MODEL : **TS-2000/X, TS-B2000**

SUBJECT : **Modulation output delays about 2 seconds toward PKD input signal**

X53-391 Control unit / Component side view
Take off the R708

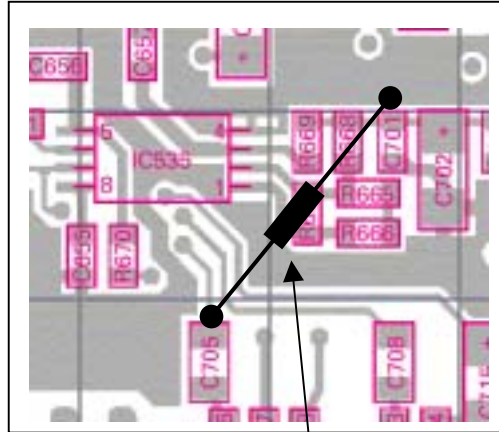
When TX is done with using ACC2 PKS terminal, modulation output delays about 2 seconds toward PKD input signal.

1. Take off the resistor **R708**
2. Attach the resistor **RD14BB2C473J** between C701 and C705.

X53-391 Control unit / Foil side view
Attach the RD14BB2C473J between C701 and C705.

IC508 X53-391 Control unit / Foil side view

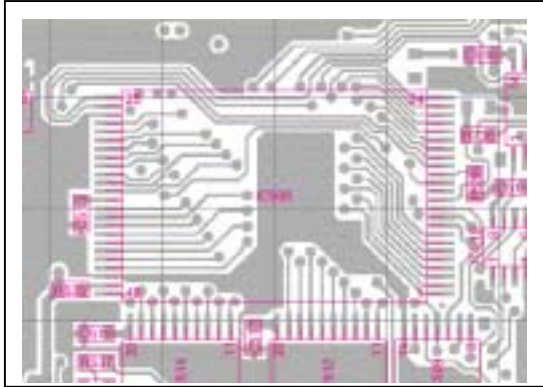
3. Exchange the IC508 (compatible parts).

29LV800BAJXQD or 29LV800BJWFD → **29LV800BAJXQE or 29LV800BJWFE.**
